## SOLICITATION AMENDMENT MODIFICATION DE L'INVITATION

<b>Title - Sujet</b> CARIBOU FERRY REPAIRS	
<b>Solicitation No. - N° de l'invitation</b> E0225-131845/A	<b>Amendment No. - N° modif.</b> 002
<b>Client Reference No. - N° de référence du client</b> 20131845	<b>Date</b> 2012-10-23
<b>GETS Reference No. - N° de référence de SEAG</b> PW-\$PWA-122-4925	
<b>File No. - N° de dossier</b> PWA-2-68072 (122)	<b>CCC No./N° CCC - FMS No./N° VME</b>
<b>Solicitation Closes - L'invitation prend fin at - à 02:00 PM on - le 2012-10-30</b>	<b>Time Zone</b> Fuseau horaire Atlantic Daylight Saving Time ADT
<b>F.O.B. - F.A.B.</b> <b>Plant-Usine:</b> <input type="checkbox"/> <b>Destination:</b> <input checked="" type="checkbox"/> <b>Other-Autre:</b> <input type="checkbox"/>	
<b>Address Enquiries to: - Adresser toutes questions à:</b> Chinye, Chukwudi	<b>Buyer Id - Id de l'acheteur</b> pwa122
<b>Telephone No. - N° de téléphone</b> (902) 496-5476 ( )	<b>FAX No. - N° de FAX</b> (902) 496-5016

Amendment 002 is raised to incorporate the following changes:

SK-1 CRIB #1

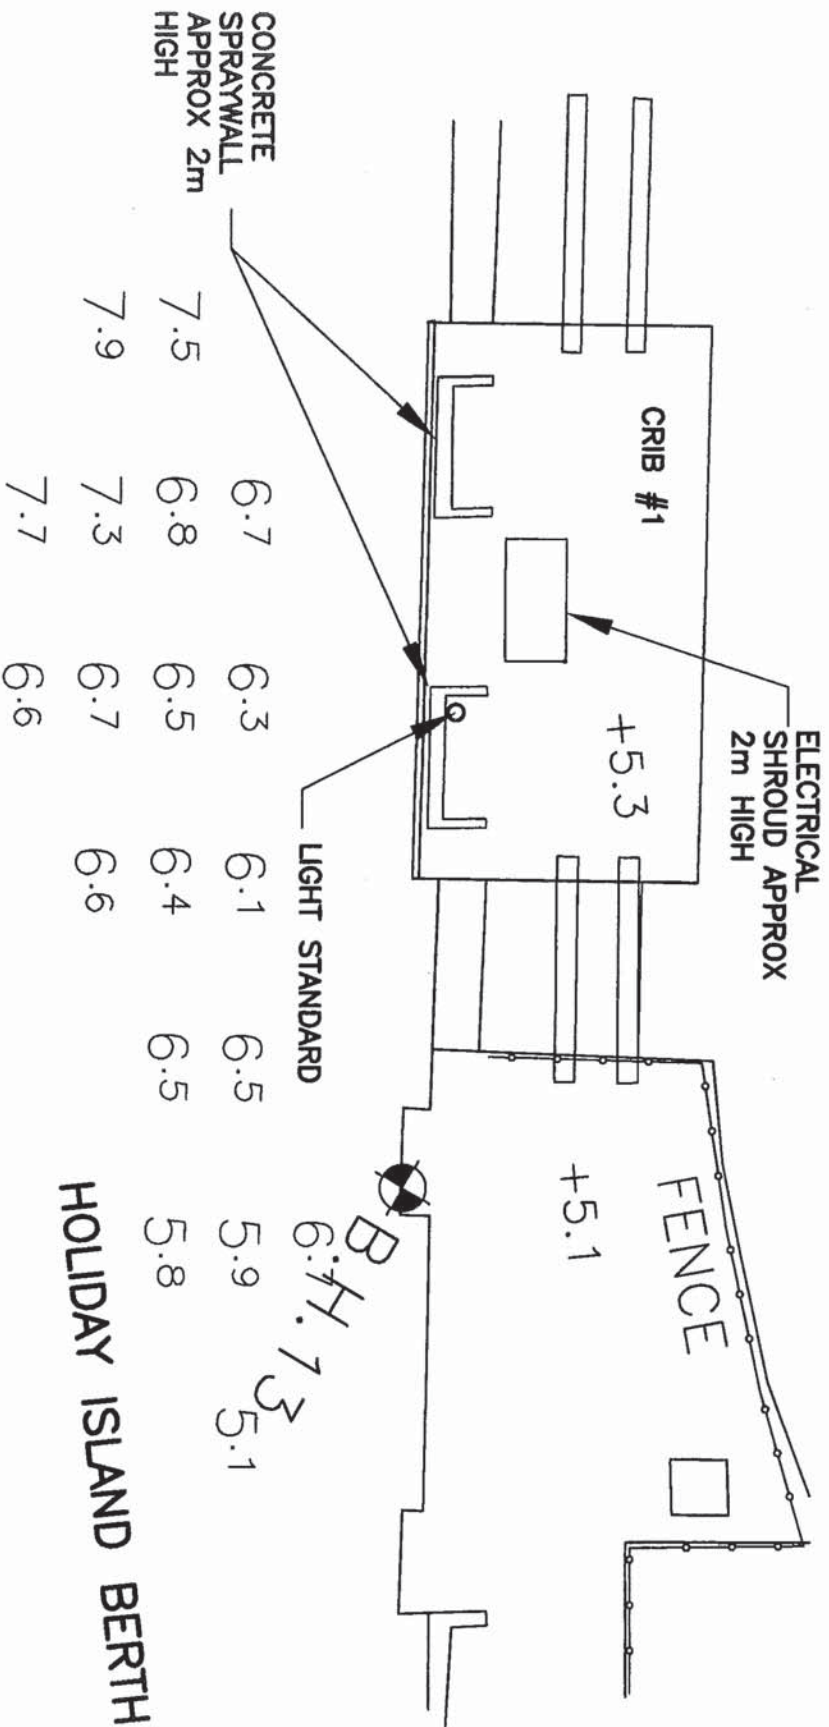
See SK-1 (page 2 of this addendum) for items located on crib #1.
